Subject: Description of Permissive Change

FCC ID: 2AK23MC120

Model Name: MC120LT, MC120BS.

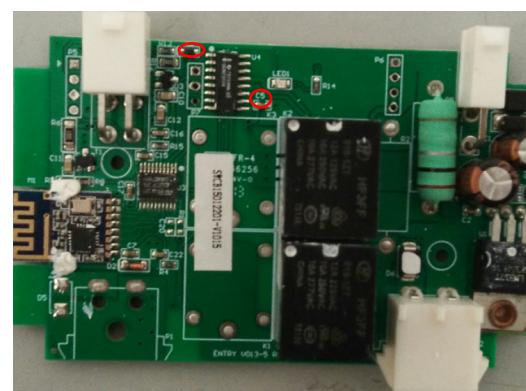
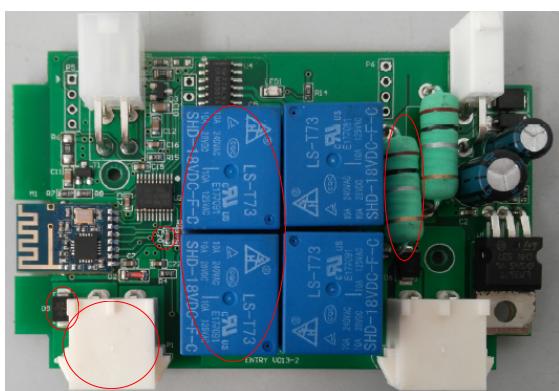
2. The board is different:

(1)Removed: K1, K3, R2, C20, P1, D5 .

(2)Added:D7,C5.
